Product Change Notification

Product Change Notification: P-26-030272

HOUSING SUBASSEMBLY, PLUG, 180 DEGREE, 1PORT, GEMnet

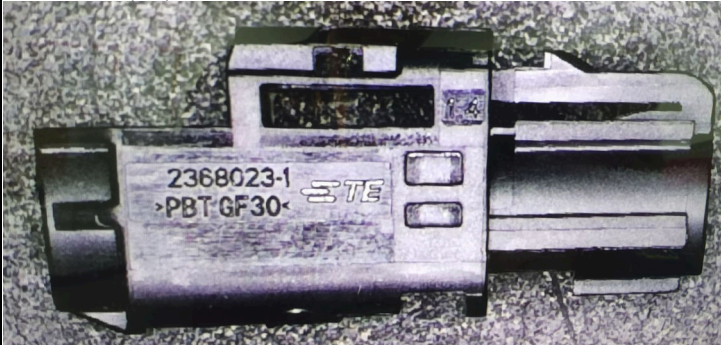
add duplicate mode. The appearance of the copied mold product is the same as that of the old mold, except for the difference in the engraved numbers of the mold cavities (the new mold cavity numbers are: 2.1 - 2.8, a total of 8 cavities; the old mold cavity numbers were: 1.1 - 1.4, a total of 4 cavities).

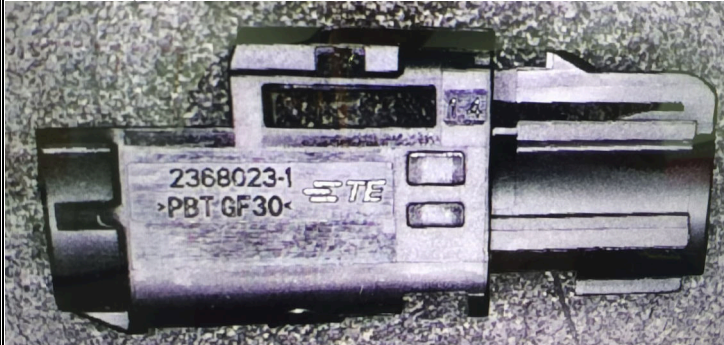
add duplicate mode. The appearance of the copied mold product is the same as that of the old mold, except for the difference in the engraved numbers of the mold cavities (the new mold cavity numbers are: 2.1 - 2.8, a total of 8 cavities; the old mold cavity numbers were: 1.1 - 1.4, a total of 4 cavities).
